Peoria Park District
Bradley Park Equipment Service Center
1314 N. Park Road
Peoria, IL 61604
Telephone: (309) 686-3386

ADDENDUM NO. ONE

PROJECT TITLE: Charter Oak South Dam Repair

ISSUANCE DATE: June 19, 2013

After repair

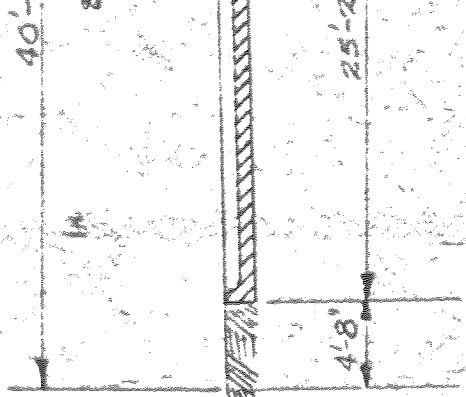
For clarification, a sheet showing the original plans, and a sheet of images of before and after the 2010 repair is attached.
